Access Compliance Report

Public Rights-of-Way

(Curb Ramps)

Intersection ID: 11540	Main Street: W MARTIN LUTHER KING JR BV	Access Street: S SUMMIT AV	Location: S
ADA ID: 8C475D9B33A9	Ramp Type: BlendTrans1	Initial Pass/Fail: Pass	Overall Compliance: No
		Severity Score: 17.5

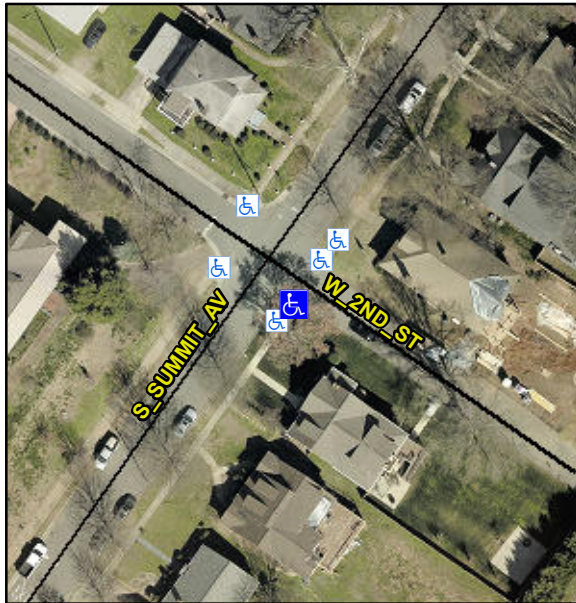
Not Found, R305, R302.7.2, R304.5.3

N/A	Ramp inside XWalk1?	N/A	N/A	Ramp inside XWalk2?	N/A
	Road Slope (%)	0.2		Clear Space?	Yes
	Road X Slope (%)	5.0	N/A	Clear Space to XWalk (in)	N/A
Yes	Any Obstructions?	No	Yes	Storm Grate/Utility Hazard?	No
	Obstruction Type			Storm Grate/Utility Type	
			N/A		N/A
			Yes	Surface Condition? (G/P)	Good
			No	Curb Slope (%)	7.9

Remove & Replace Curb Ramp With Two New Directional Ramps or Equivalent. Remove & Replace Gutter.
